**BOARD OF ZONING ADJUSTMENT
STAFF REPORT****Date: May 7, 2018****CASE NUMBER**

6173/6046/5840/5113/4902/4883

Annaleigh A. Nowling

LOCATION1714 Dauphin Street
(Northeast corner of Dauphin Street and Semmes Avenue.)**VARIANCE REQUEST**

SITE PLAN

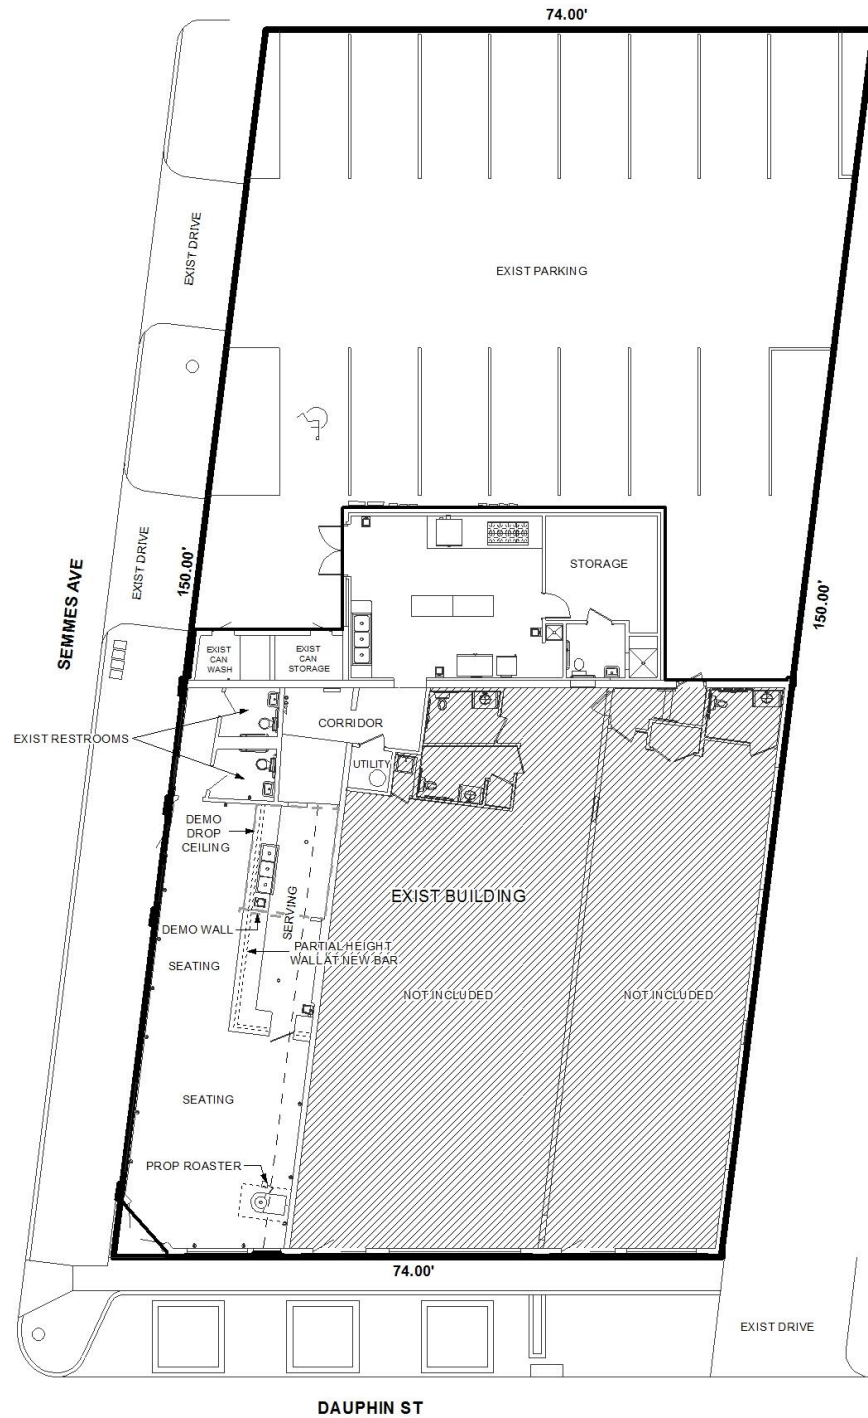
It should be noted that the site plan provided only illustrates the subject site, and not the adjacent site with which it will share access. As such, approval of the requests will require revision of the site plan to include both properties.

- 1) Revision of the site plan to include the adjacent property with which the subject site will share access and parking;
- 2) Provision of a narrative justifying use of the property for coffee roasting; and,
- 3) Provision of a narrative identifying how the applicant will minimize the impact of noise on surrounding properties as a result of live music performances.
